Statutory Public Meeting & Recommendation Report Plan 20M-824

Delegation Presentation
by Kevin Rutherford
January 13, 2020

Block 5 (Condominium Townhomes) Compliance with RO2/RO2-488

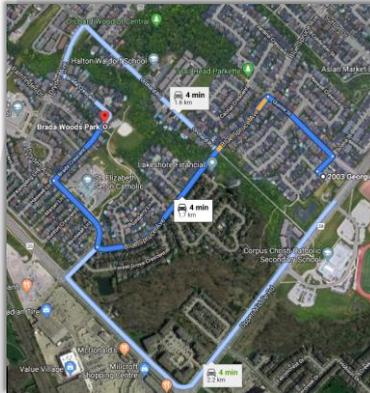
Condominium Townhomes as planned have a density of 66.67 UPH
(screenshot taken from developers site plan)

Allowable density for medium density residential townhomes as per City of Burlington zoning regulations for RO2 and the Exceptions in RO2-488 is 50 UPH

Park Space

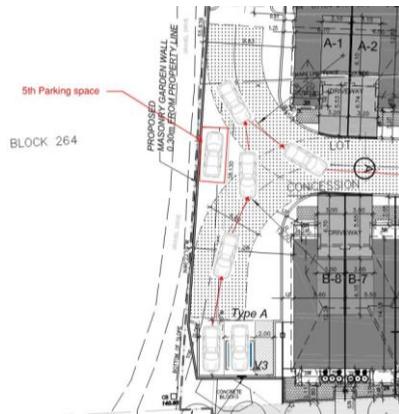
Approximately 0.009 ha of land is to be dedicated to the City for a public walkway/overland flow route. An 8.1 ha park (Orchard Woodlot) is located within 250 m of the subject site, and a 2.2 ha park (Brada Woods Park) is located within 800 m. Staff have determined through the rezoning that adequate parkland is available to accommodate this development. As such, cash in lieu of parkland dedication is recommended (Condition 9a), Appendix B).

Proposed

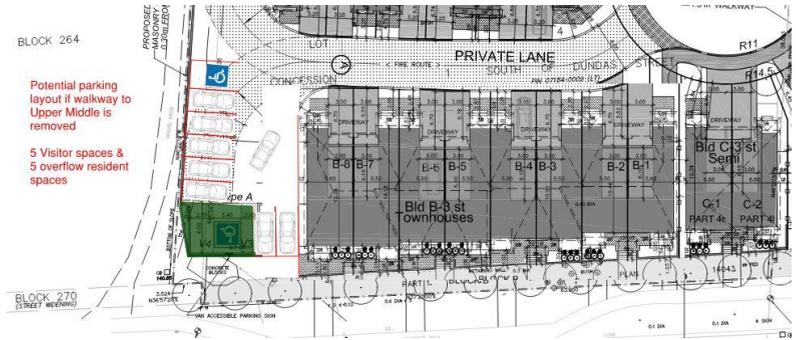
- Parking provided is inadequate for the development;
- Lot widths for townhomes have been reduced to the point where compact cars may not even fit in garage;
- Existing steets (Rome & Georgina) accommodate 22 on-street legal parking spaces

- Existing parking including 5th space is awkward, inefficient and inadequate in addressing neighborhood concerns
- Removing the proposed walkway to Upper Middle Road allows for significantly increased parking on site
